■ Appearance Differences Due to Specification Changes

■ Part numbers subject to specification changes

【Before change】

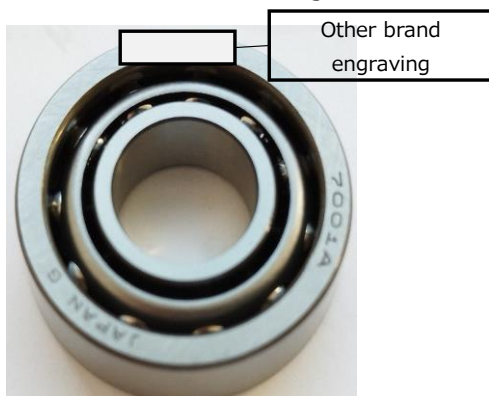
※There is a possibility that products and packages before and after the change may be mixed in the same shipment, but there will be no problems with use.

<Package>
